PARTS & SERVICE NEWS

REF NO. AA99172

SUBJECT: NEW SEAT AVAILABLE FOR 330M / HD785-3

PURPOSE: TO INTRODUCE PRODUCT IMPROVEMENT KIT AK4242

Figure 1. Improvements of New Seat

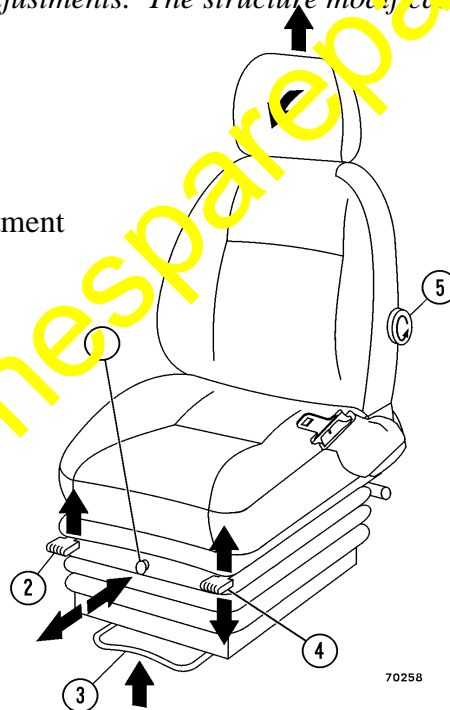
An improved operator's seat is now available for 330M / HD785-3 trucks built in the U.S. with serial numbers A10211 and below. This seat is standard with new production trucks effective with A10212. The seat is a quality, heavy-duty, air suspension seat. Dual dampers (suspension) are standard with this seat. Air supply for seat suspension is provided by the truck's air system. The seat is also equipped with a three inch wide retractable seat belt. *NOTE: The cab floor must be lowered by a structural modification to allow for full range of height adjustments. The structure modifications are part of the AK4242 kit.*

- Heavy duty construction
- Dual dampers
- More Adjustments
 1. Weight \ firmness adjustment
 2. Back rest angle
 3. Front-to-rear-travel
 4. Ride height adjustment
 5. Lumbar support

Figure 2. General Overview of Required Modifications

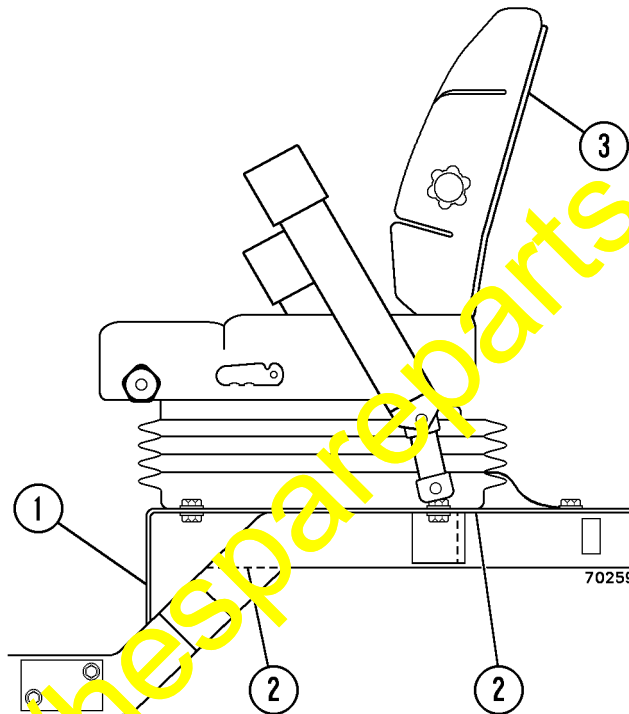
*NOTE: This installation requires significant cutting and welding operations to the cab floor. **Take all necessary precautions to prevent a fire during cutting and welding operations.** To install the new seat, the floor has to be lowered approximately 3 inches to allow for the full range of seat height adjustments. Refer to Figure 2 for an overview of required cab floor modifications. No other cab, electrical or plumbing changes are required.*

- 1. Seat Support (to be removed)
- 2. Cab Floor (to be cut out)
- 3. Old Seat (to be removed)

1. Remove existing seat and rework cab platform per drawings EH4904 and EH5568.
2. Install new seat (EH7882).
3. Install new belt and tethers (PC0541;PC0564).
4. Instruct operators on seat adjustment.
